Sirajgonj Fashions Ltd.

101/01/A, Barabagh, Mirpur-2, Dhaka – 1216, Mirpur, Dhaka, Bangladesh.
(23.803278N, 90.364693E)

18th February 2015

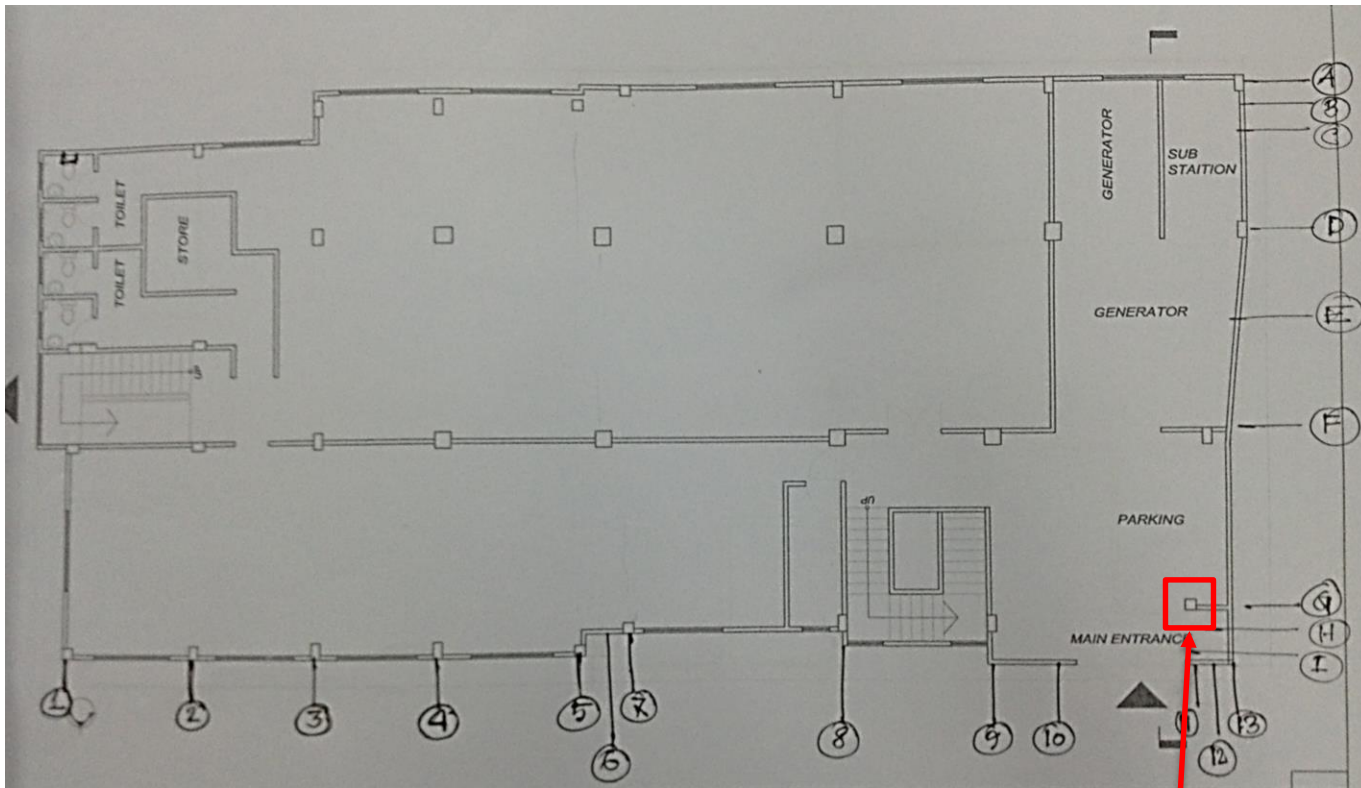
Unbraced brick walls at 5th floor level

Unbraced perimeter brick walls at 5th floor level

Discrepancies between site observations and information on drawings

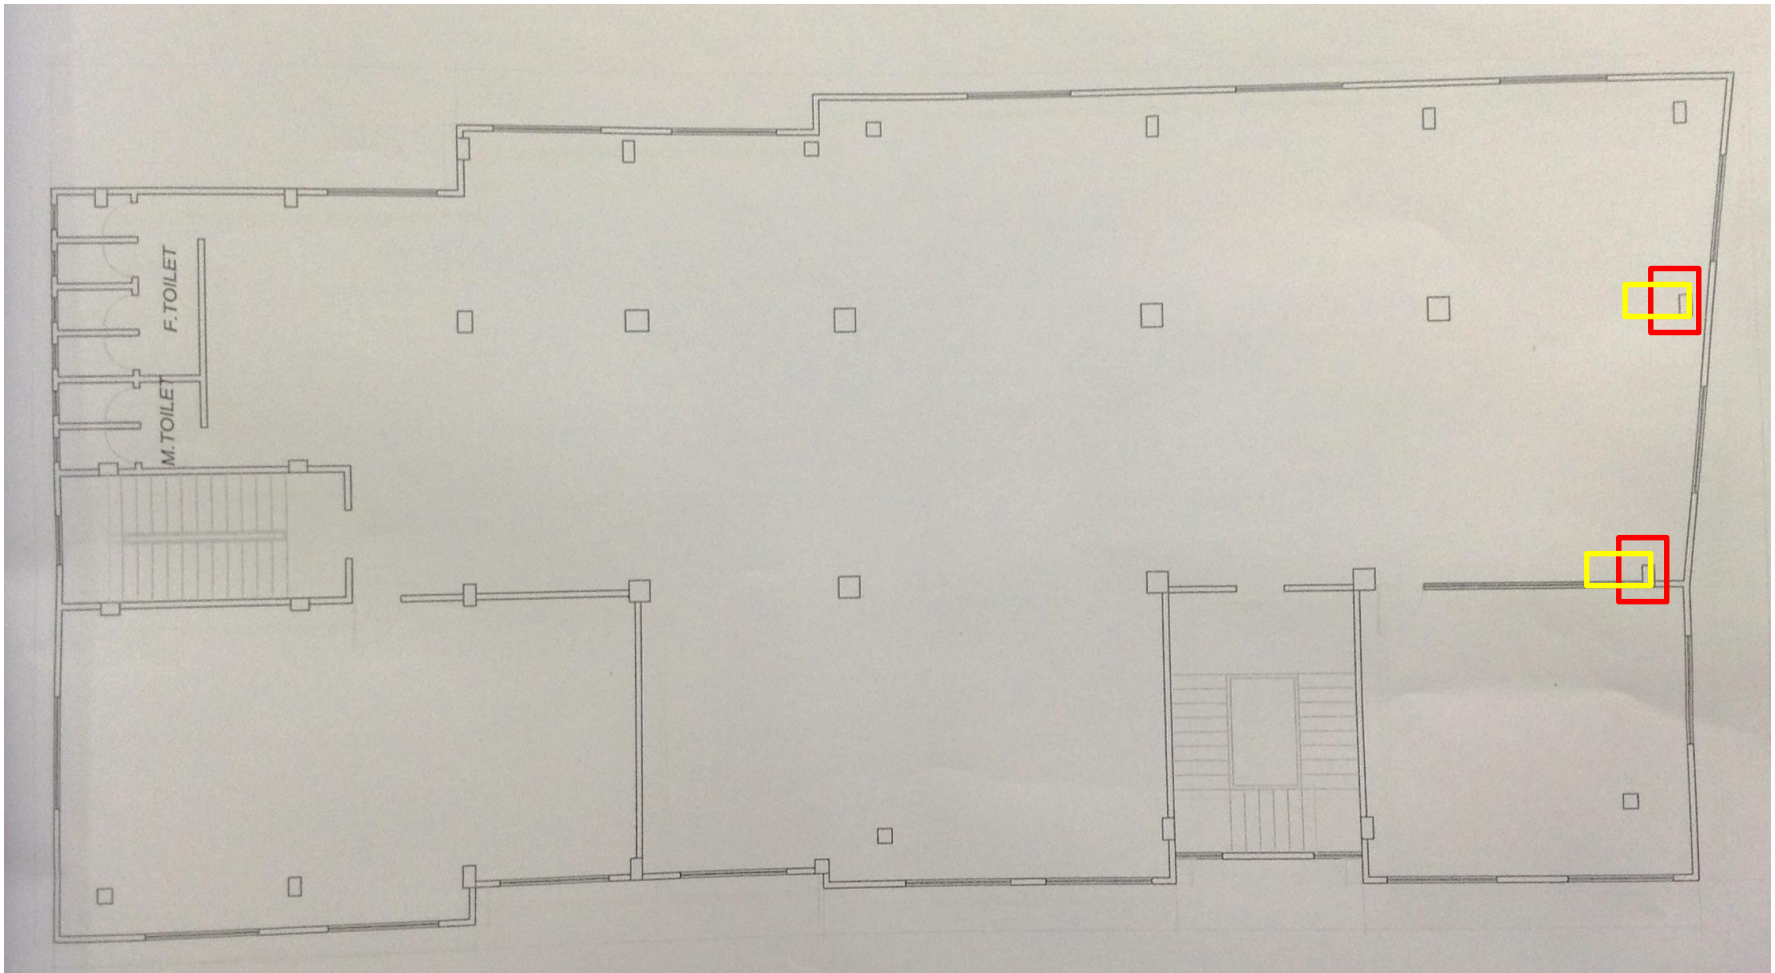
Alignments of columns in drawings

Alignments alignment of columns observed on site

Most column dimensions are different on site from drawings.
